Addendum No.: 3

Date of Addendum: June 2, 2020

Willard Diloreto Parking Garage
Paul Manafort Sr. Drive
New Britain, CT
CF – RC – 402

The following clarifications are applicable to drawings and specifications for the project referenced above.

E-2 STAIR #3 - WEST ELEVATION
SCALE: 1/4" = 1'-0"

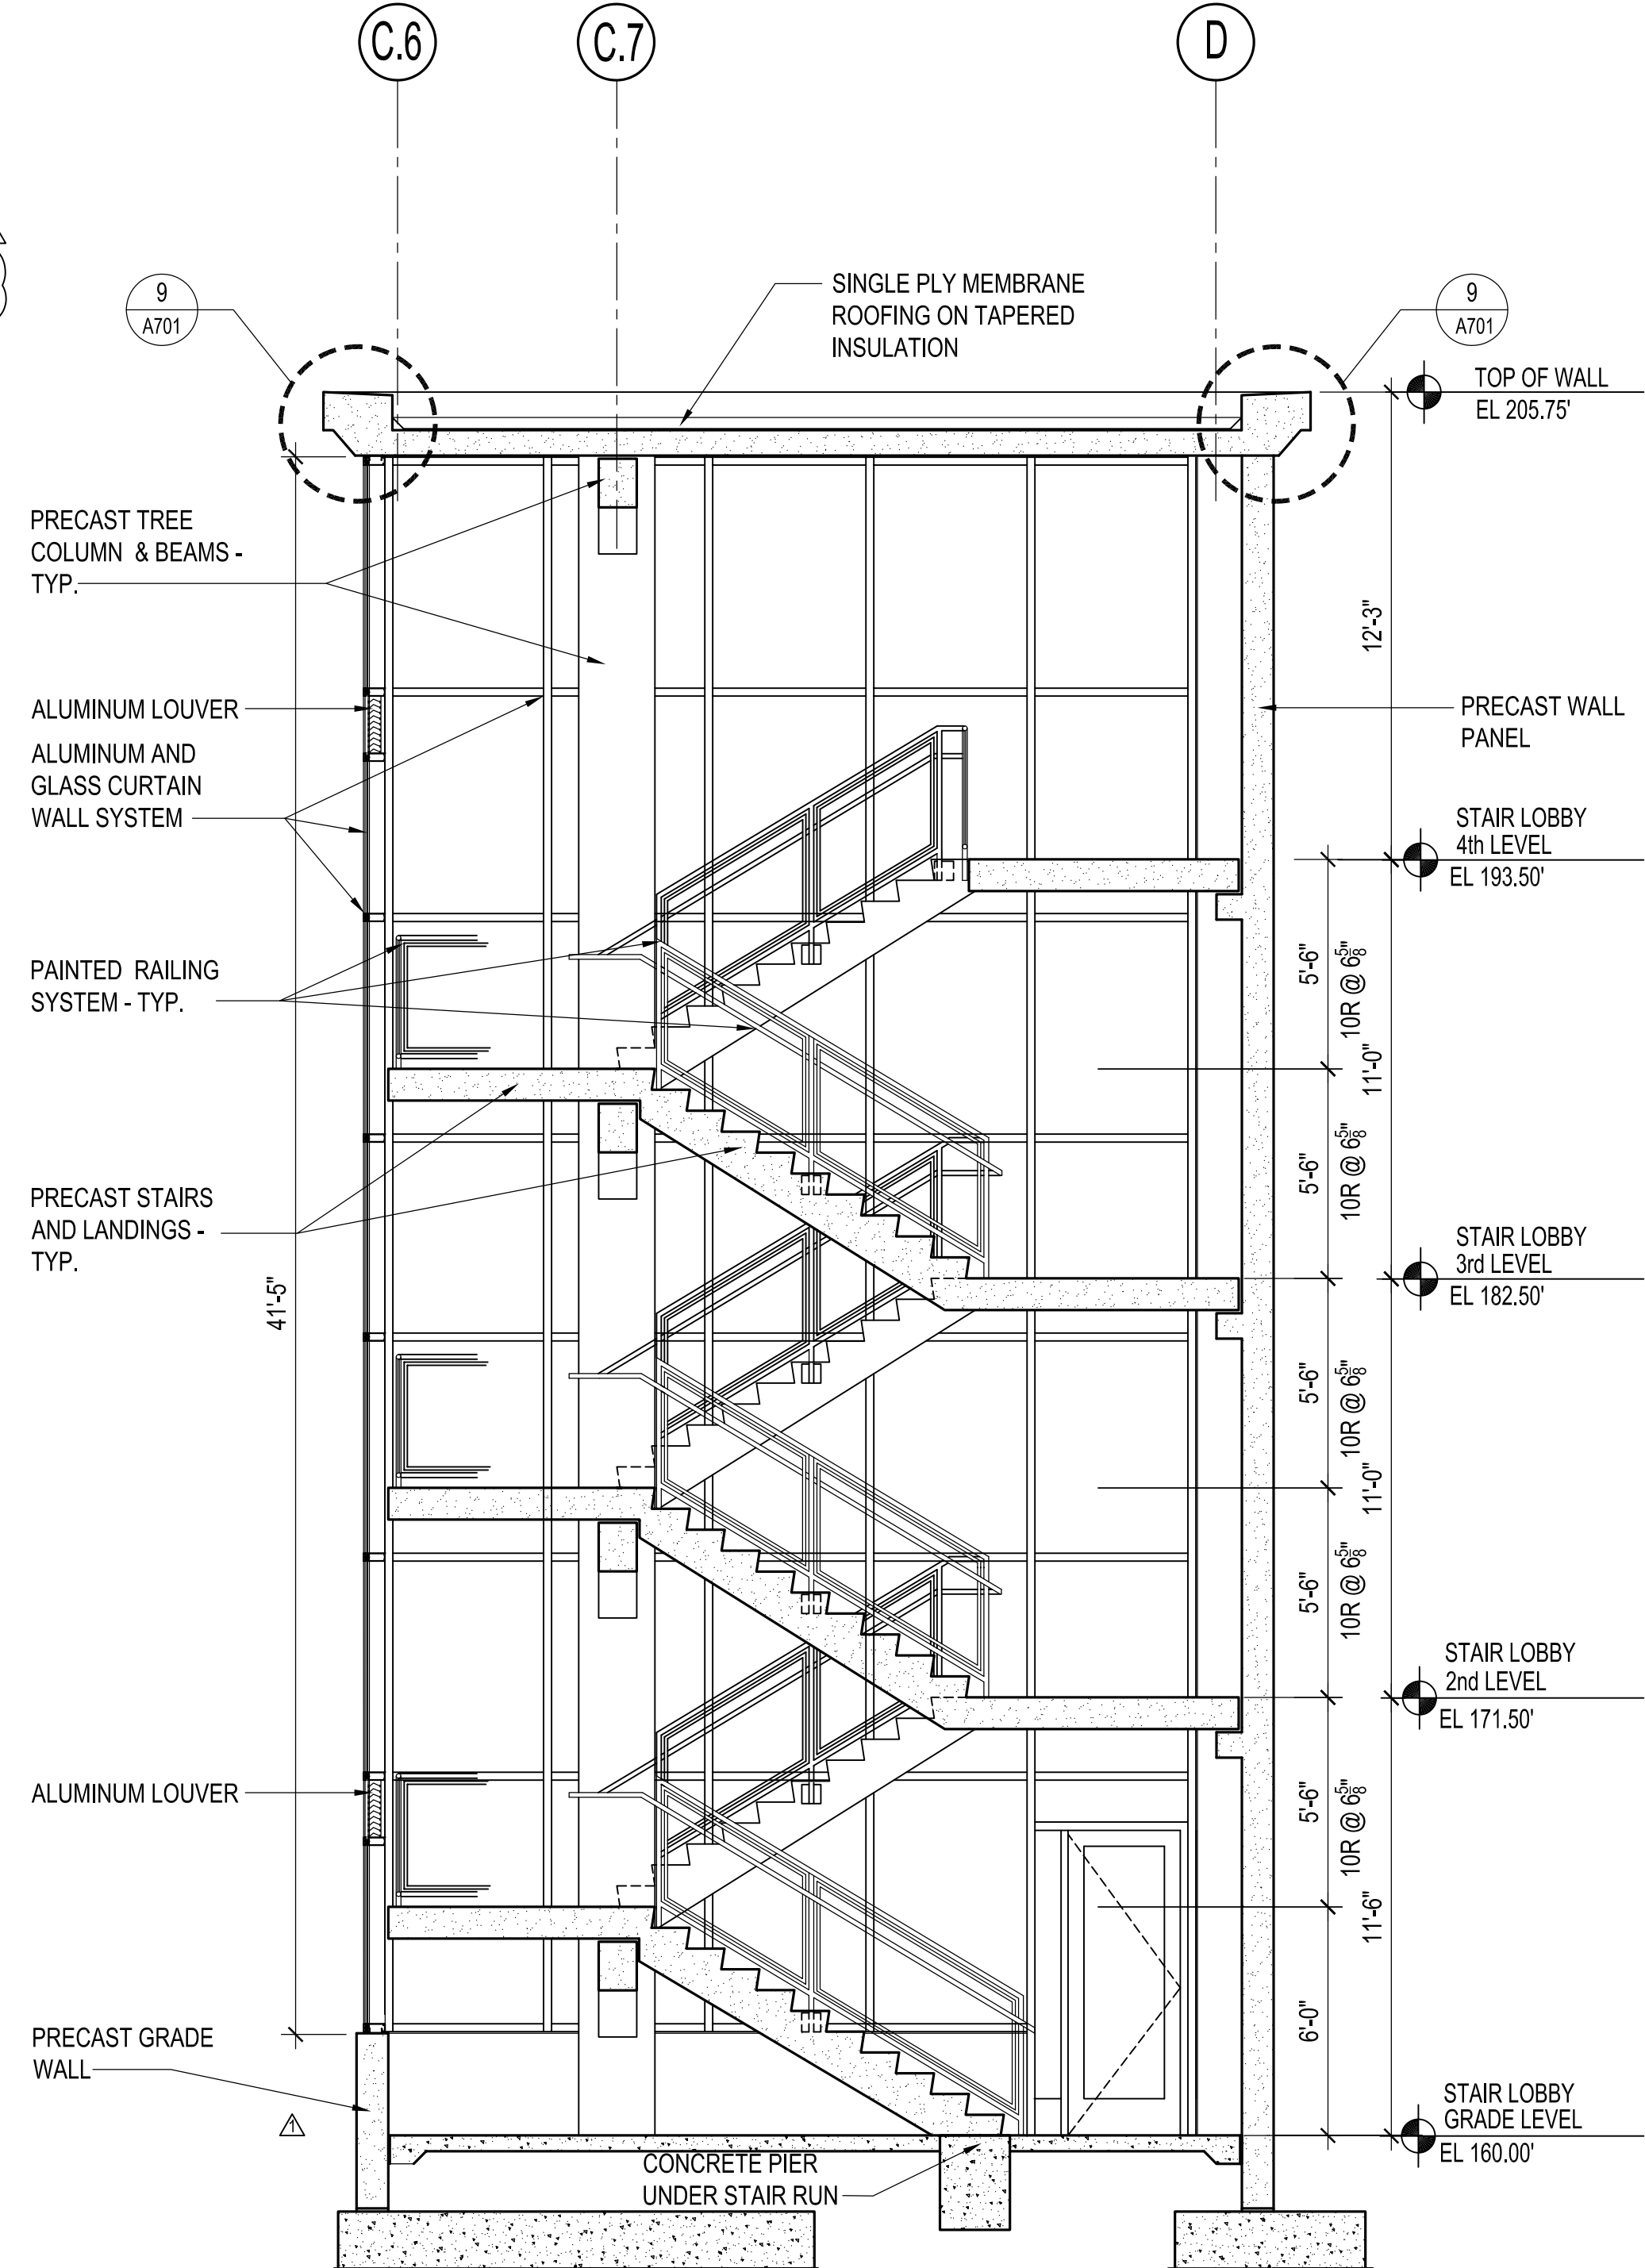
Question: Layout and Elevation Drawings- We do not find any drawings or details that clearly define the edge/end finish of the wall panels with the built-in-pilasters located along the North & South Elevations of the garage. The Elevations show a 'thin brick' finish on the exterior face of the wall panels, but the return portion (edge of panel with built-in-pilaster) is not clearly defined. Detail cuts '2', '3', & '4', from drawing A203, and Wall Section 2 on drawing A601, do not indicate a requirement for thin brick on return portion of the precast wall panels. Please provide a detail showing the finish for the return portion (edge/end of panel with built in-pilaster).

Answer: See revised drawings A203, A402, A407, A409, A601 and A602 showing extents of thin brick and thin brick returns at openings.
